ANTHEM APPEAL

BY PATRICIA DAMERY

1.26.2021

ANTHEM

BERM QUANTITIES EXHIBIT

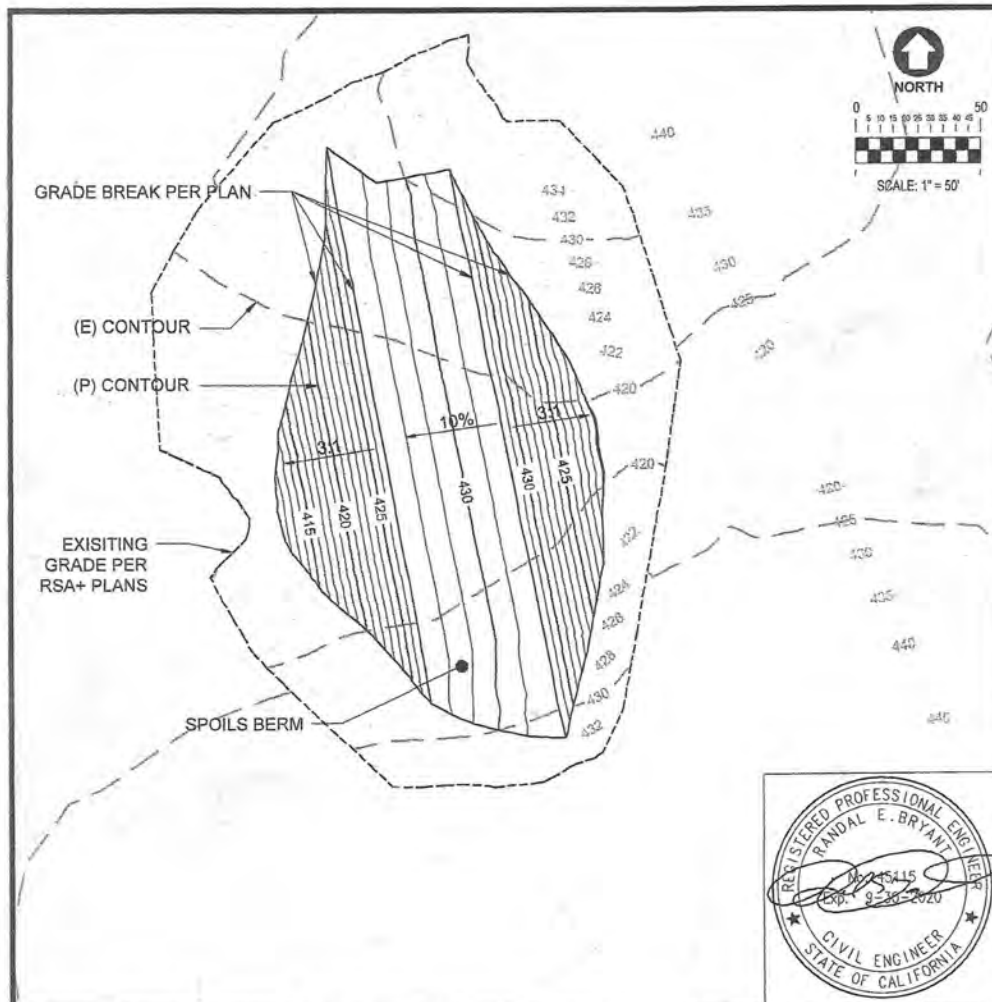
29 TRIPS

EXISTING AND FINISH GRADE INFORMATION IN THE REGION DELINEATED ABOVE IS PER THE ANTHEM WINERY GRADING & EROSION CONTROL PLAN BY RSA+ DATED 6/5/2018. EXISTING GRADE OUTSIDE OF REGION IS SHOWN AT 5' CONTOURS PER THE NAPA COUNTY 2003 LIDAR AERIAL SURVEY.

**3D VIEW BERM
QUANTITIES EXHIBIT
(SOUTH VIEW)**

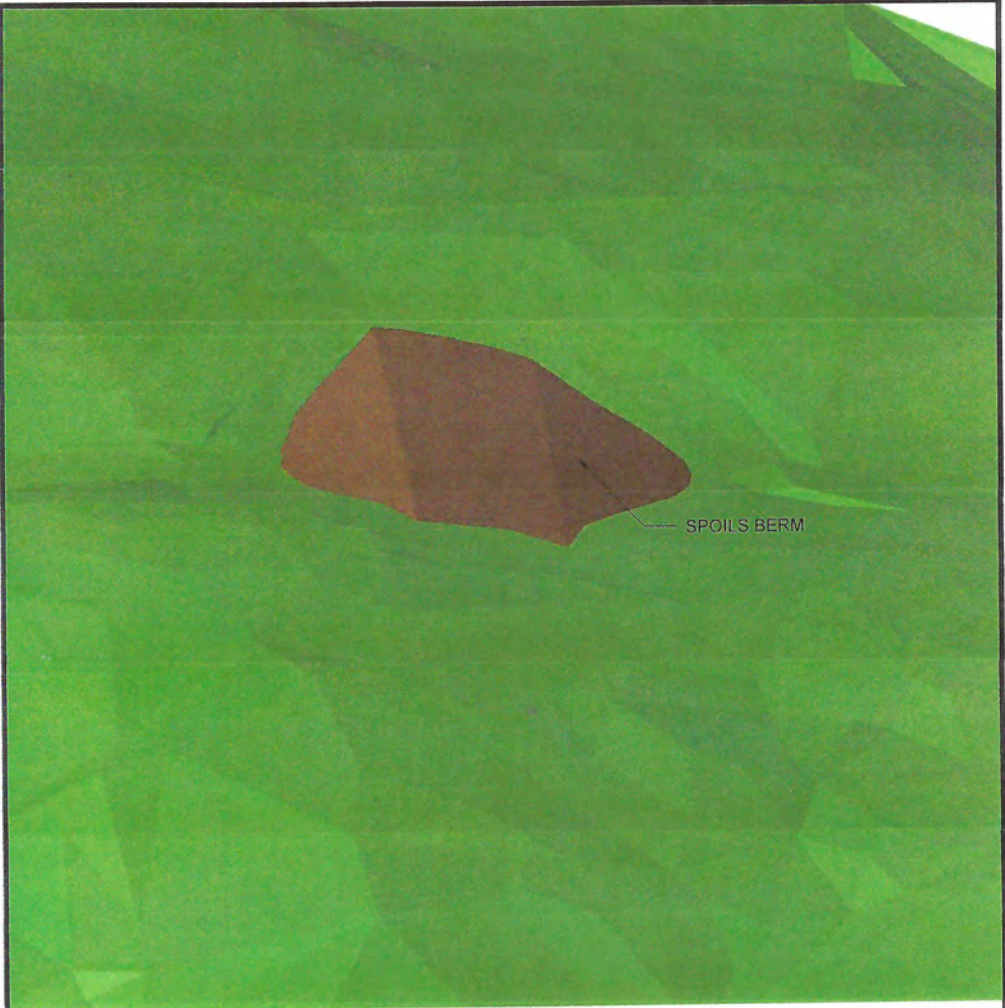
SPOILS BERM
